2007 - 2013 Cadillac CTS-V: GM TechLink: Low Oil Pressure on V8 Engines

Subject: Low Oil Pressure on V8 Engines

Source: GM TechLink

Fig. 3

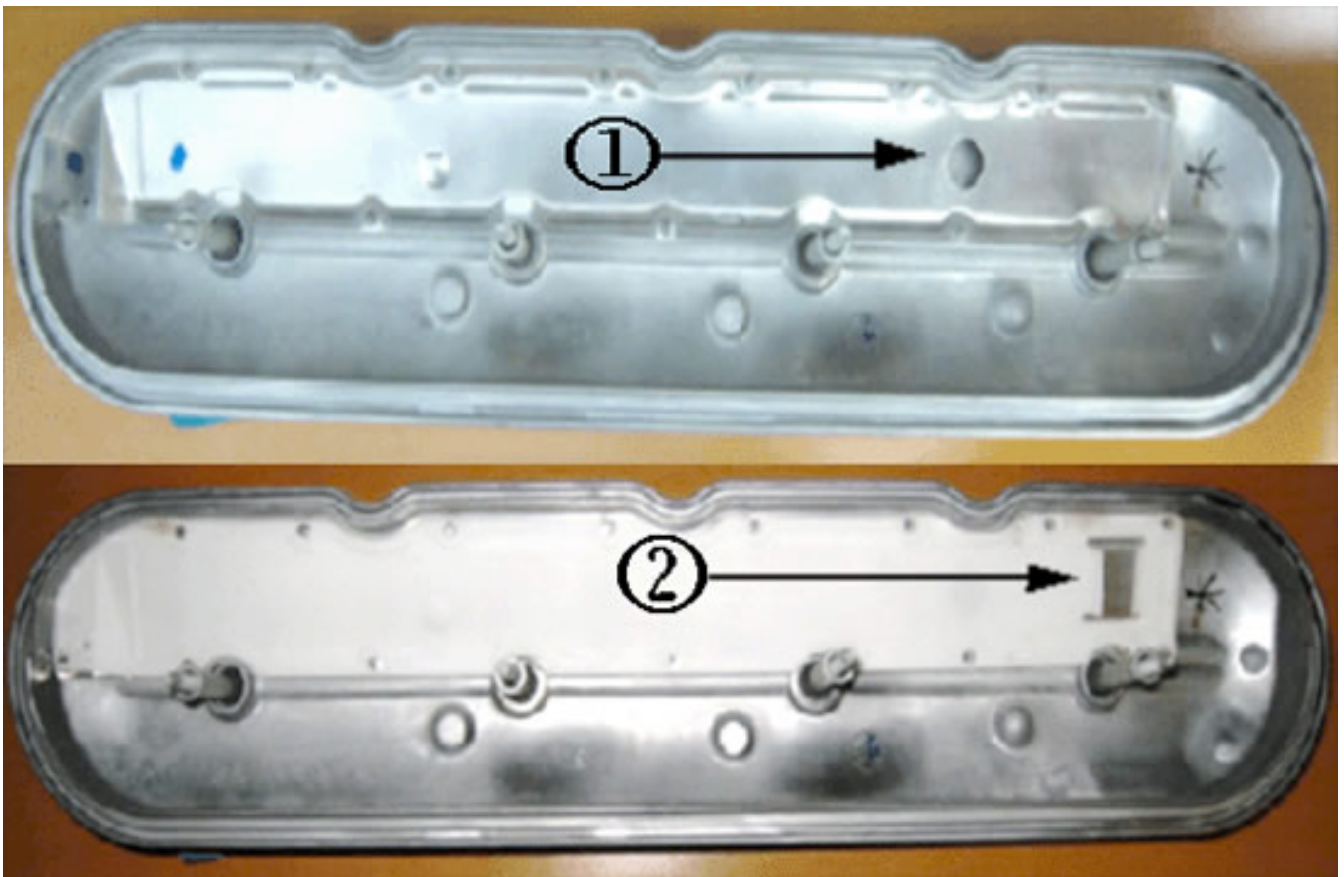
If the engine has been properly repaired and cleaned, inspect the left rocker cover (square baffle) (Fig. 3, #1 – old design; #2 – new design with square baffle) and verify that the baffles can hold water and do not leak. If any leaks

are found, clean and seal the edge of the baffle with RTV, if possible, or replace the valve cover. Thoroughly clean and dry the valve cover before installation and/or resealing.
